**CERTIFICATE OF APPROPRIATENESS**

**Property:** 7542 Cayton Street, Lot 12, Block 44, Glenbrook Valley Neighborhood Subdivision. The property includes a historic 1,712 square foot, one-story brick single-family residence and an attached garage situated on a 8,050 square foot interior lot.

**Proposal:** Alteration: Replace Front Door

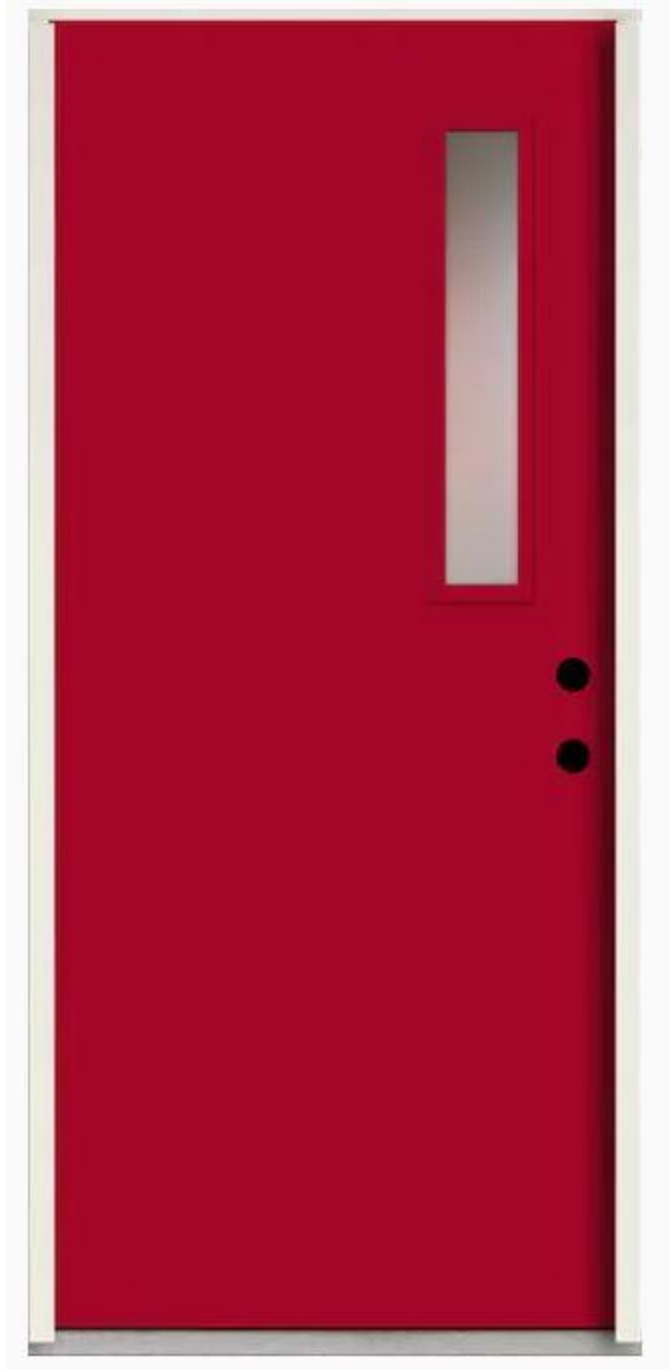
|                                     | <input checked="" type="checkbox"/> | <input type="checkbox"/>            | (1) The proposed activity must retain and preserve the historical character of the property;<br><span style="color: red;">Mid-century doors have windows that are closer to being like squares or rectangles. Mid-century doors do not have inset paneling. None of the proposed doors from the applicant are in character with this contributing historic structure.</span>  |
| <input type="checkbox"/>            | <input checked="" type="checkbox"/> | <input type="checkbox"/>            | (3) The proposed activity must recognize the building, structure, object or site as a product of its own time and avoid alterations that seek to create an earlier or later appearance;<br><span style="color: red;">All of proposed doors from the applicant are not of the period of this structure.</span>   |

<p><b>Recommendation:</b> Approval with conditions: historic district.</p> <p><b>HAHC Action:</b> -</p>	<p><b>Work with staff to find an appropriate door befitting the</b></p>
---	---
